Upgrading the Pacific Highway

Warrell Creek to Urunga

Submissions and preferred
project report

Part 3A Response to Submissions and Preferred Project Report

Figure 3-1 - Realignment through Newry State Forest

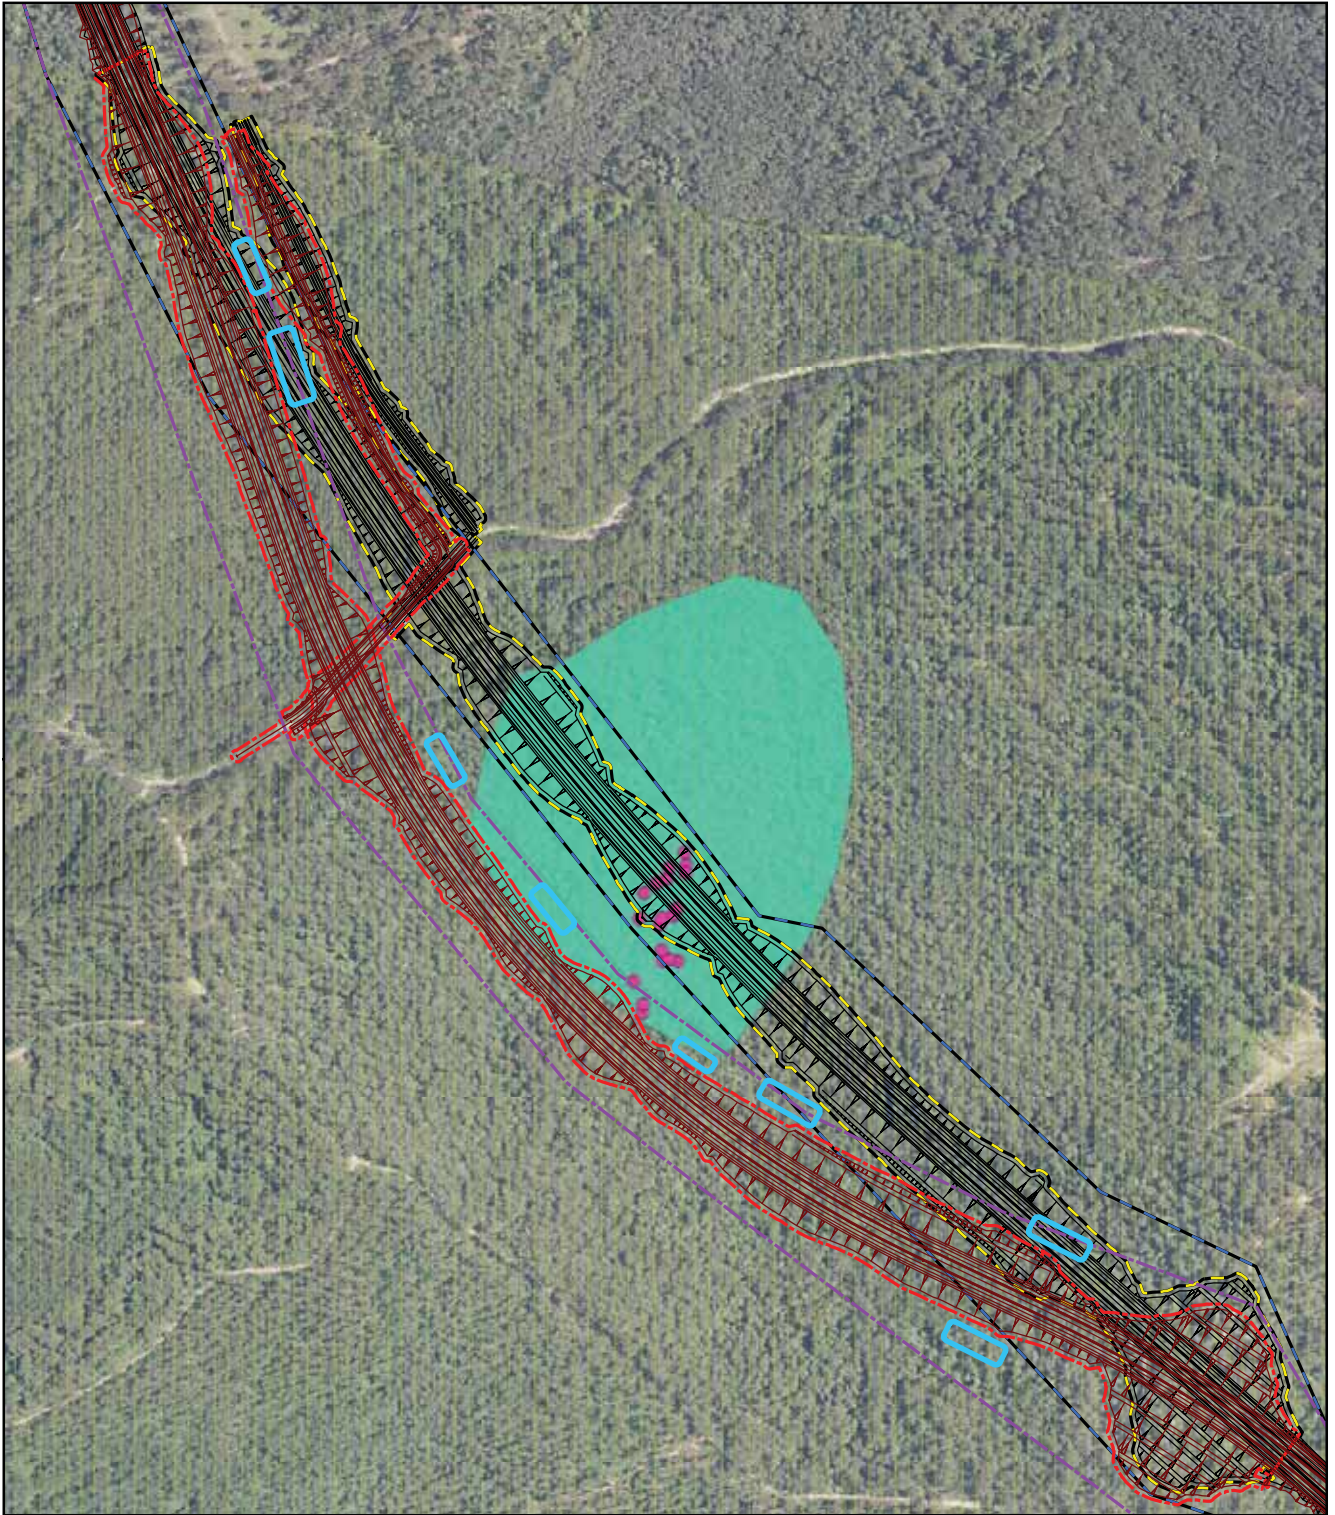
Figure 3-1 shows the location of the alignment as depicted in the environmental assessment and the proposed realignment through Newry State Forest.

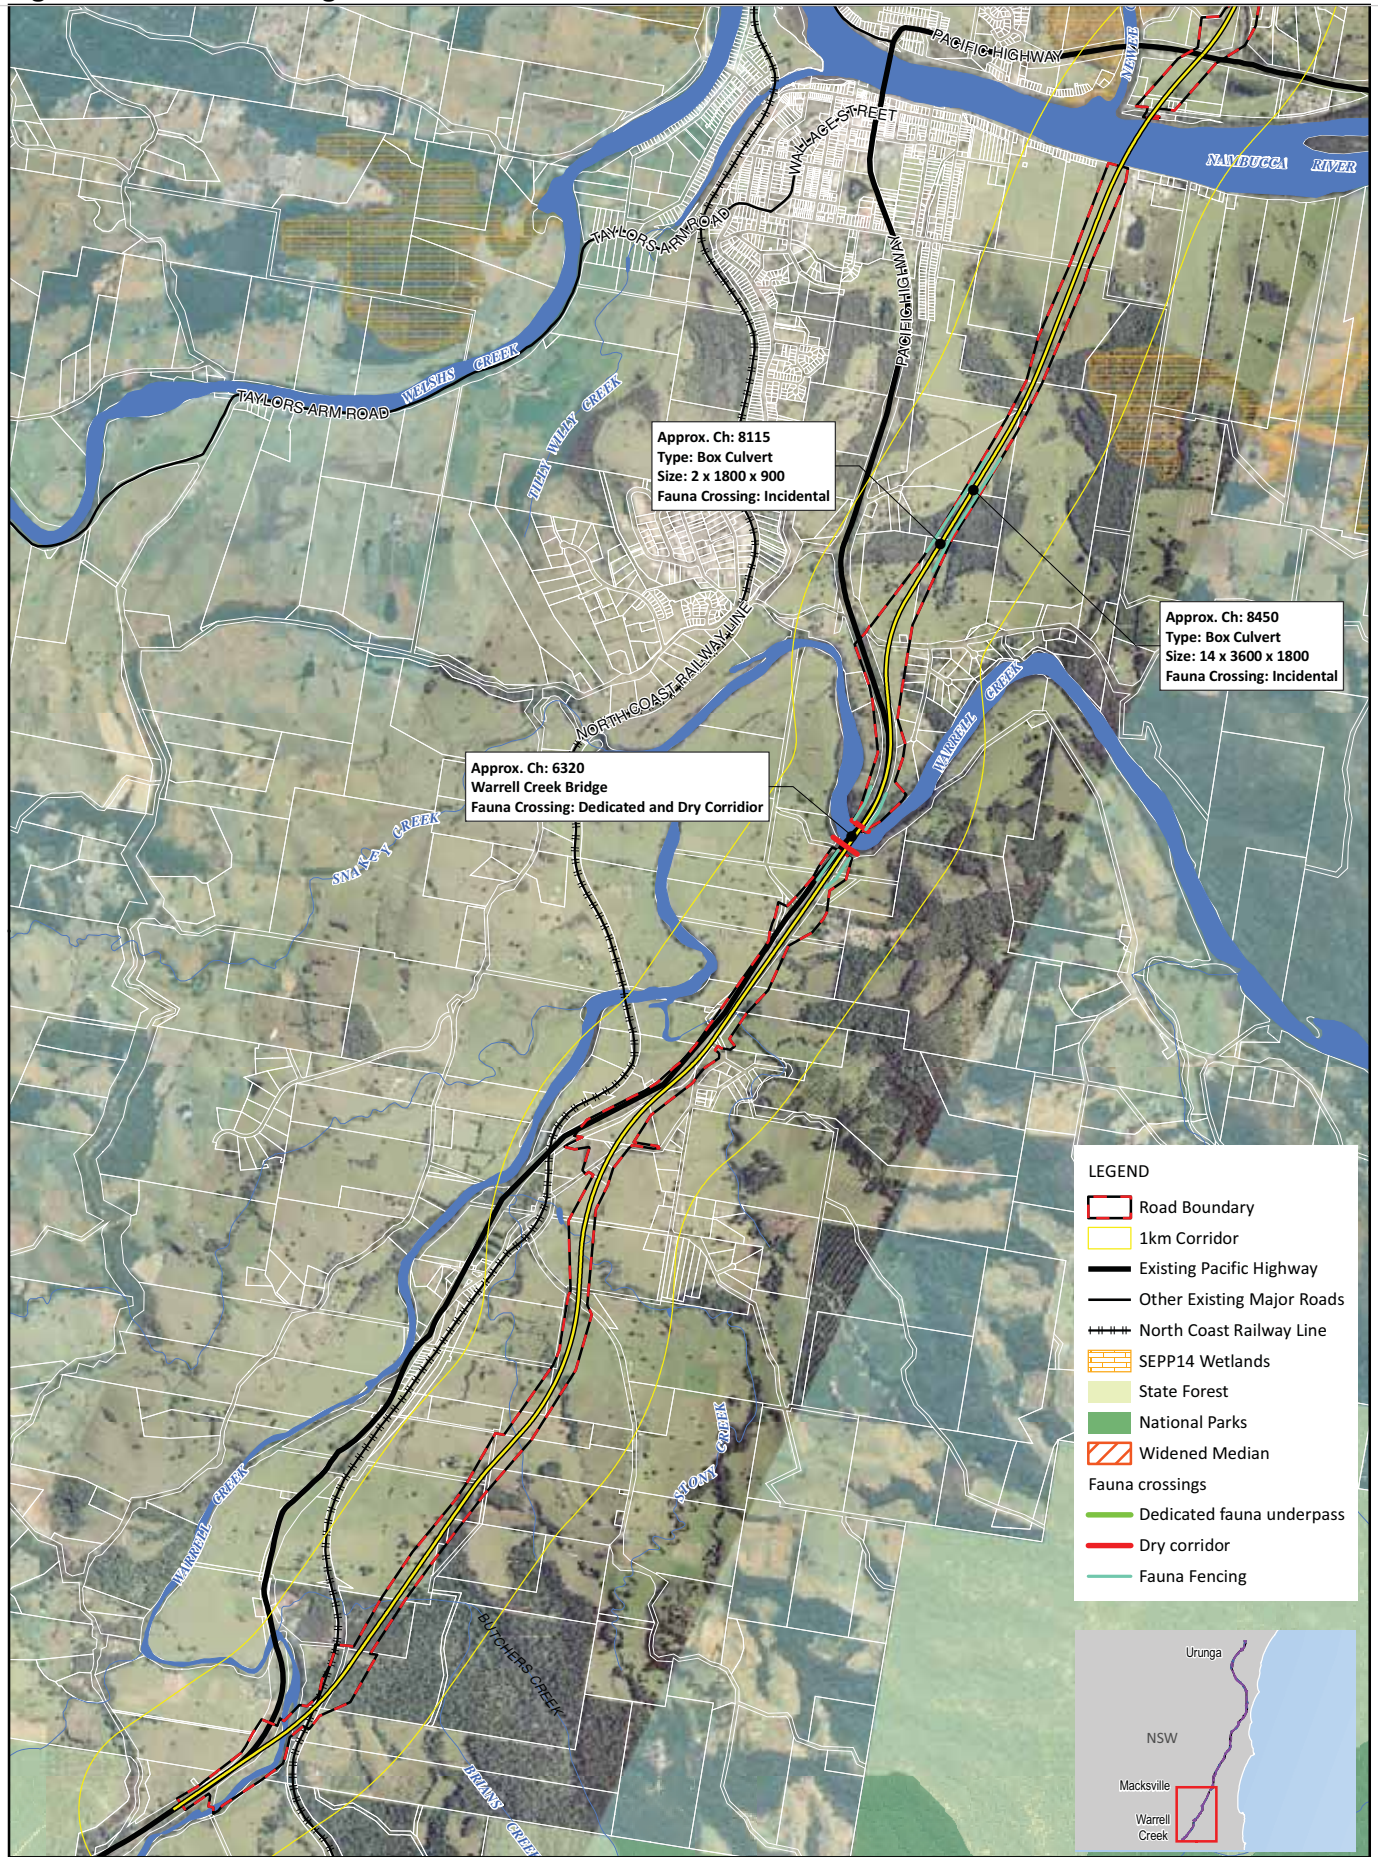
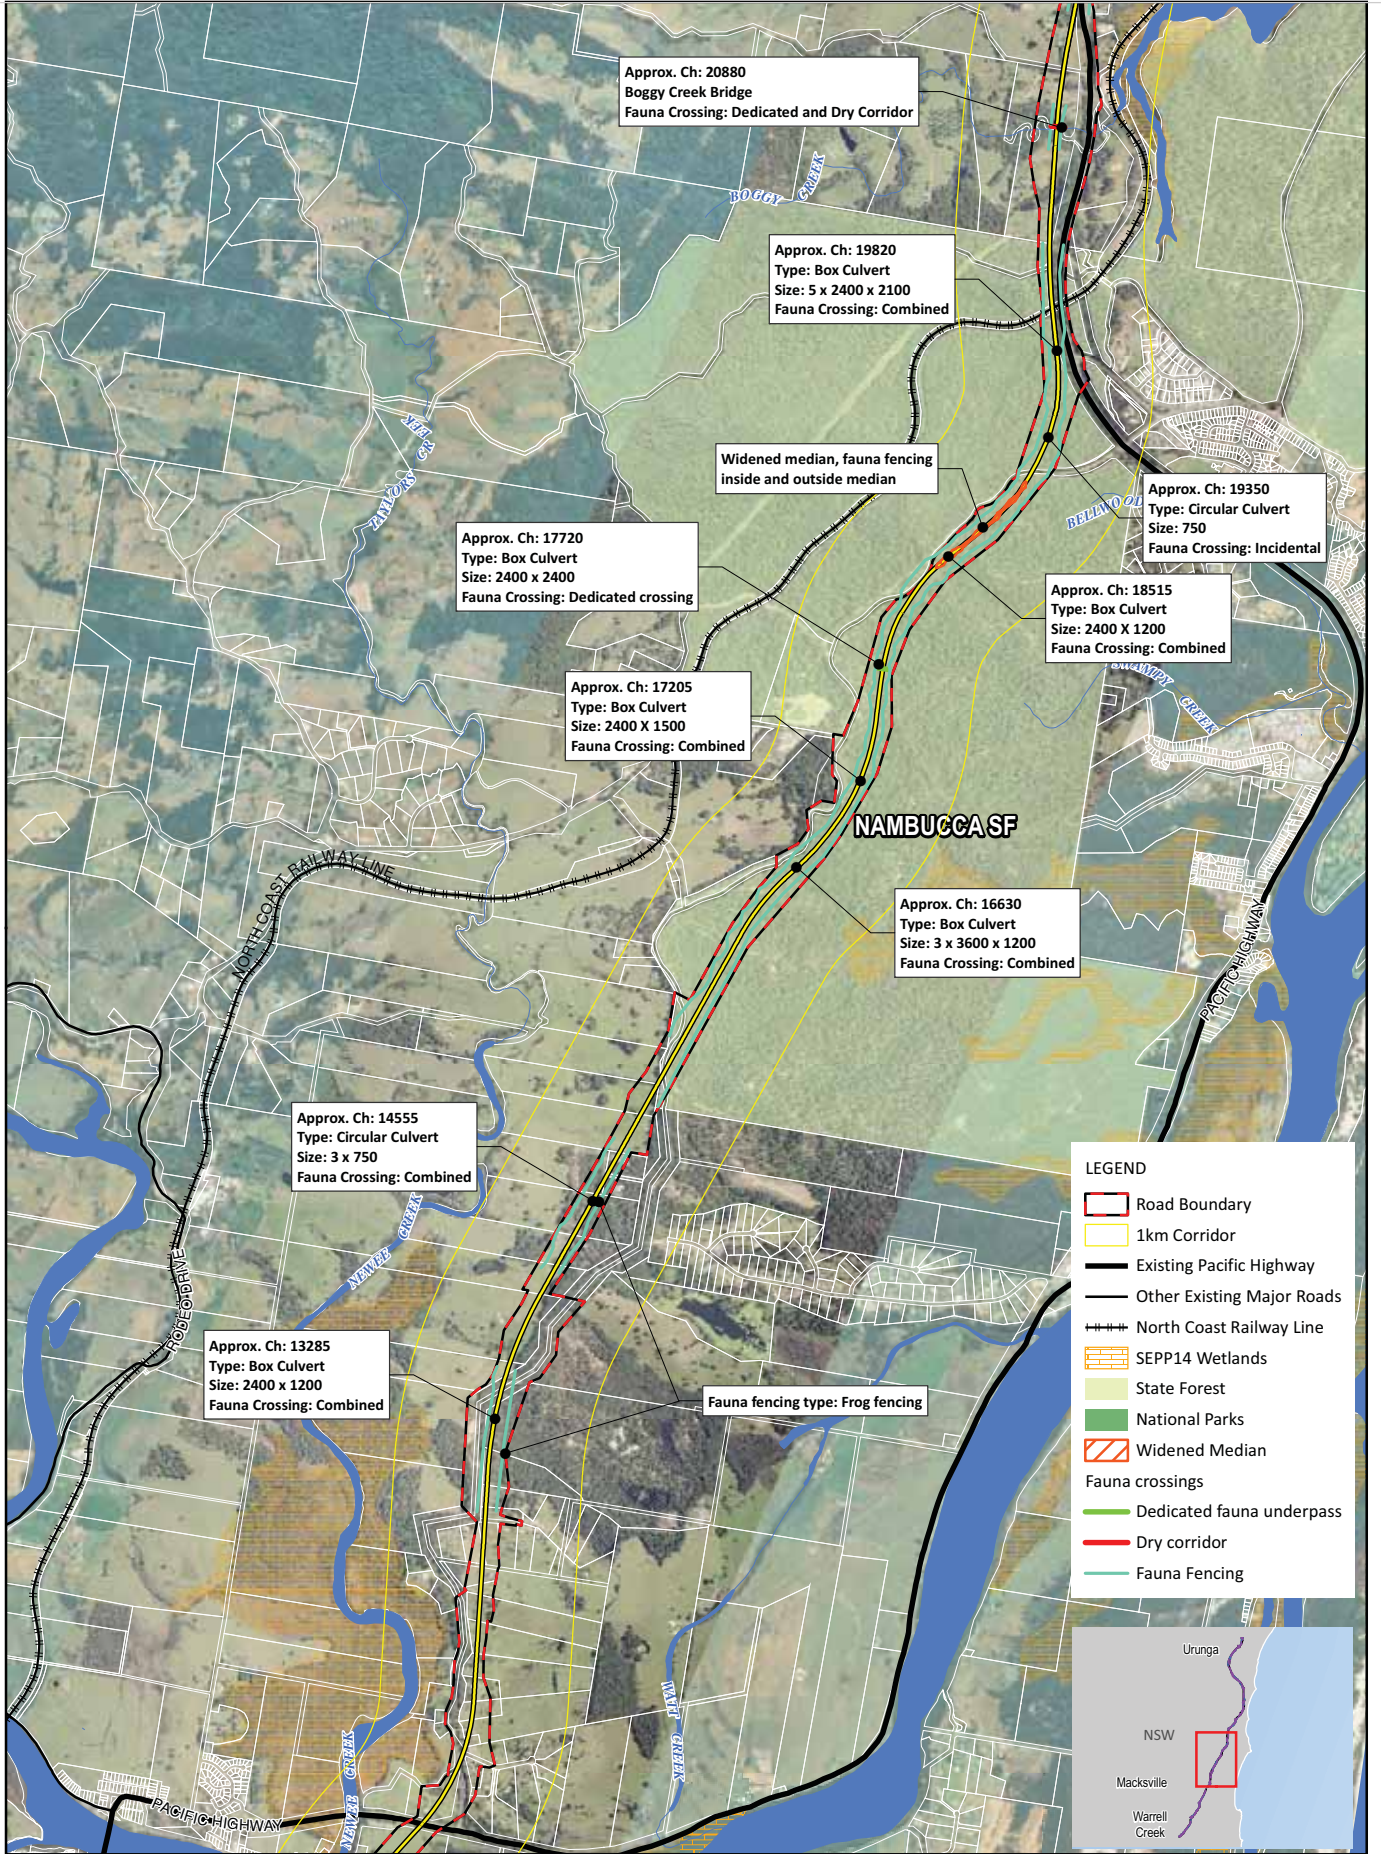
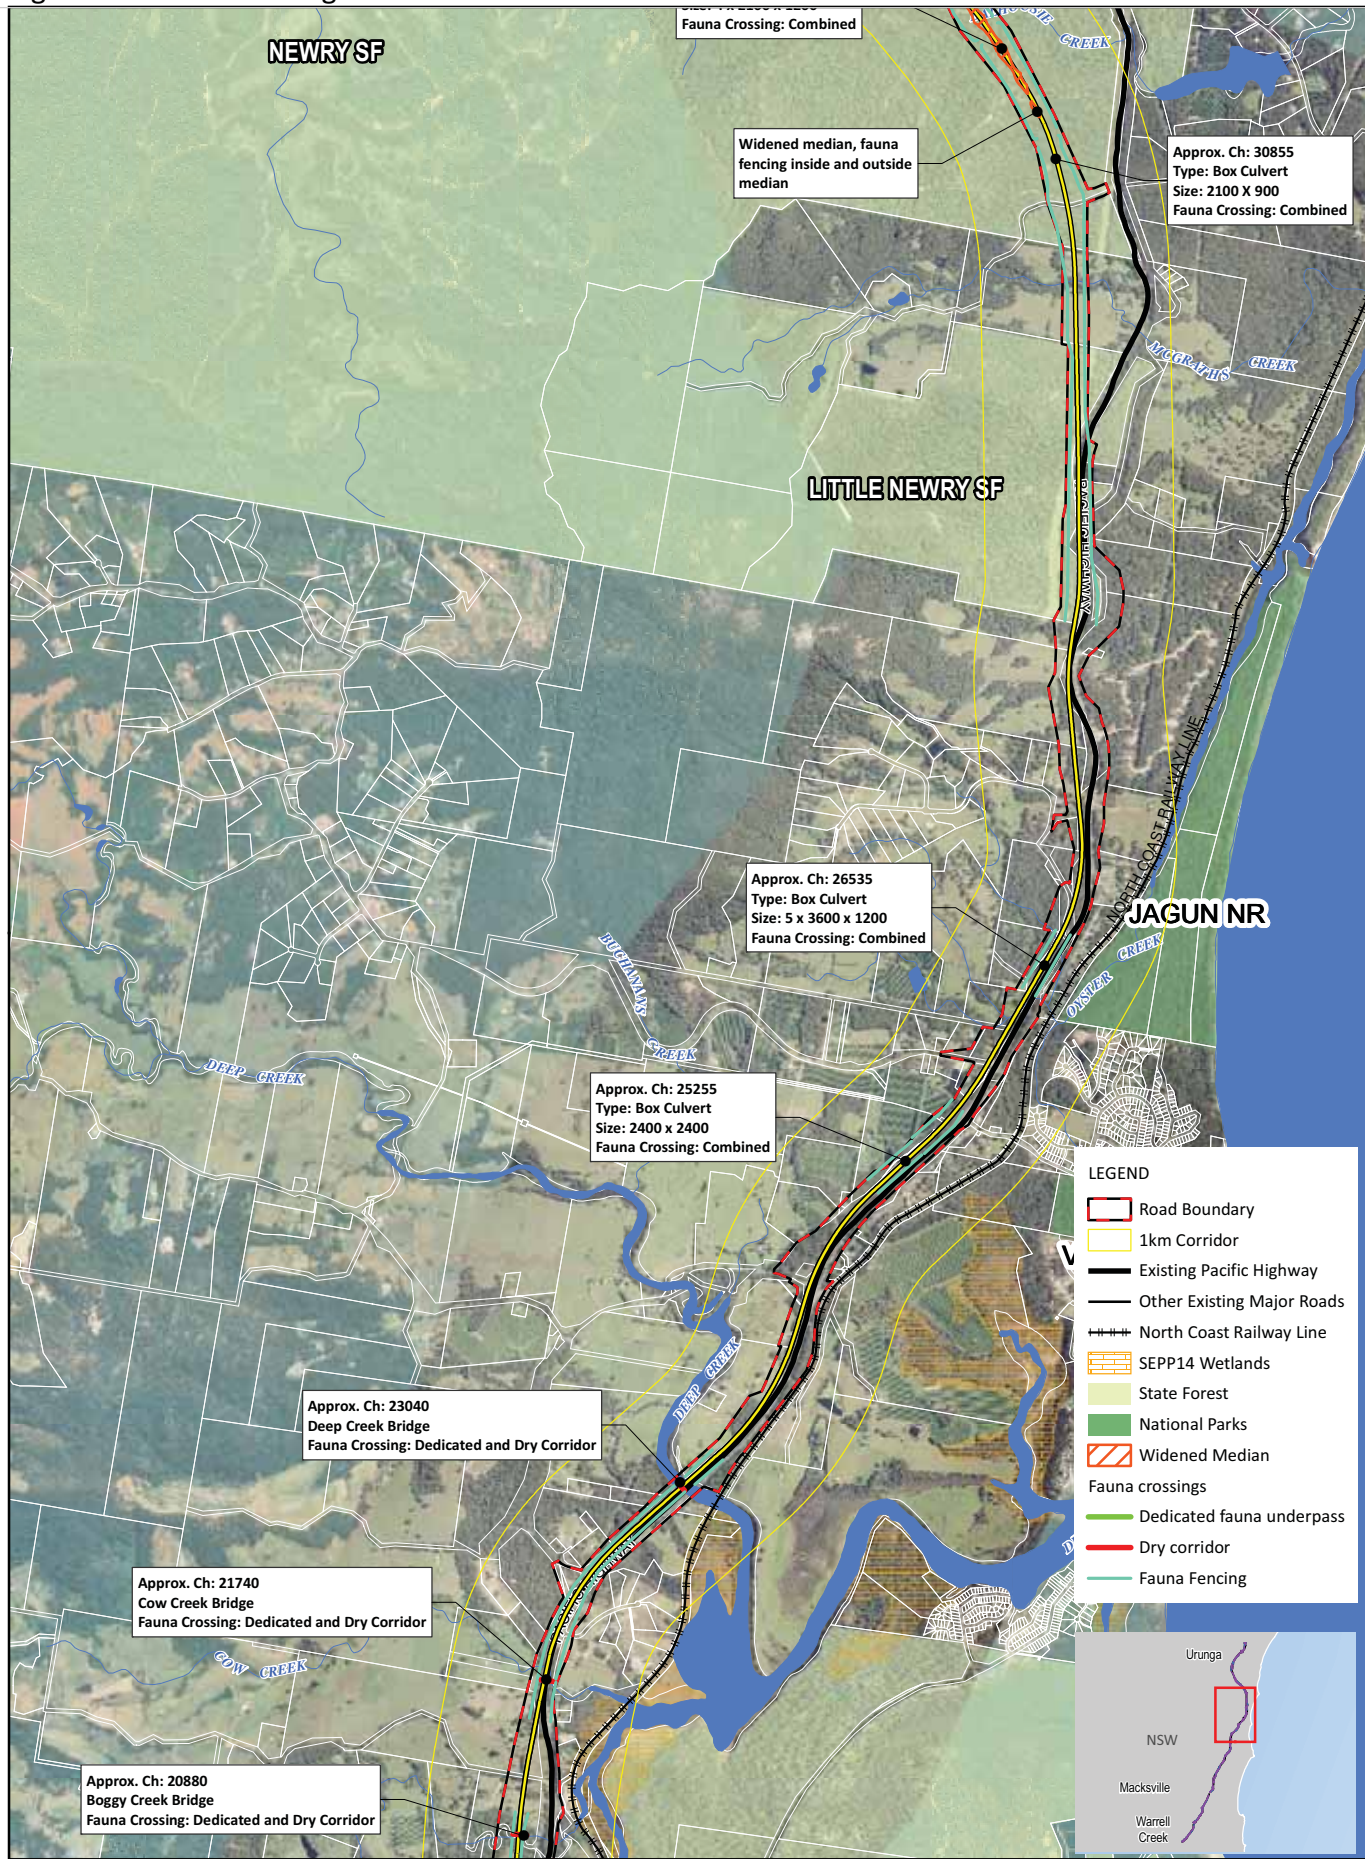
Figure 3-2 shows the details of the cross-drainage structures, where there is to be fauna fencing, along the length of the Proposal. The proposed crossings provide for both fish and terrestrial fauna movement. Fauna fencing is proposed to direct fauna to fauna crossing structures and to prevent access to the road corridor.

There are several dedicated fauna crossings within key wildlife corridors. A dedicated fauna underpass is proposed for each Newry and Nambucca State Forests and a dry fauna corridor through vegetated areas to the north of the Kalang River. In addition combined fauna crossings are proposed along the entire length of the Proposal.

Widened medians are proposed throughout the Proposal (including Nambucca State Forest (section 2), Newry State Forest (section 3) as well as private property in section 4). These have been designed to maintain mature vegetation and to facilitate the safer movement of yellow-bellied gliders and other glider species across the upgrade. The length of widened median proposed to assist with fauna crossing totals two kilometres.

Note: Fauna fencing locations are indicative to be refined at detailed design in consultation with DECCW
